DOCKETED	
Docket Number:	24-OPT-03
Project Title:	Soda Mountain Solar
TN #:	265224
Document Title:	Request for Information #1
Description:	This transmittal provides representative photos of the access roads proposed for use north of the I-15.
Filer:	Hannah Arkin
Organization:	Resolution Environmental
Submitter Role:	Applicant Representative
Submission Date:	8/4/2025 2:19:11 PM
Docketed Date:	8/4/2025

This transmittal provides response #1 to the CEC's Request for Information dated 7/31/2025.

Map Key

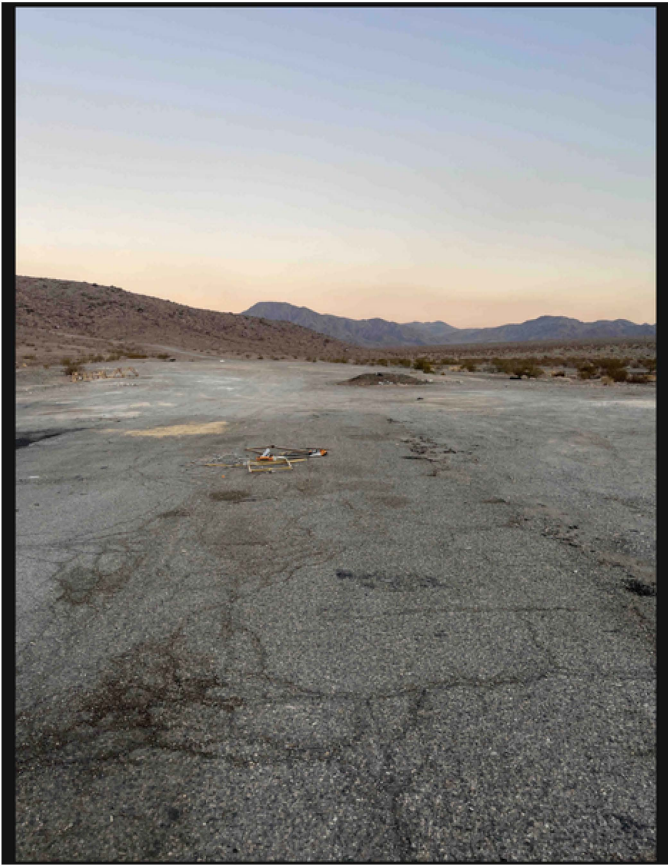
REV 2 DR BIO-2. Additionally, the applicant will provide the specific BLM road-classifications and representative photos for CL8854 and CL7682 within 1 week of determination that the project is data complete.

Response: This transmittal provides representative photos of the access roads proposed for use north of the I-15. The use of these access roads would not require any roadway improvements or maintenance outside of the project's identified development footprint. To ensure no improvements are required, the applicant will utilize all terrain construction vehicles with oversized tires and elevated clearances. The use of all terrain construction vehicles will allow project travel along these roadways without any improvements or maintenance. All road-classifications are "BLM Primitive Roads Managed for Limited Public Motorized Use".

CL8845 is proposed for use as part of the project to access the gen-tie alignment. CL8847, from Zzyzx Rd to where it connects with CL7682 is proposed for use. CL8854, CL8835, CL381A, and CL8837 are not proposed for use and were previously included in the figures for references purposes only.
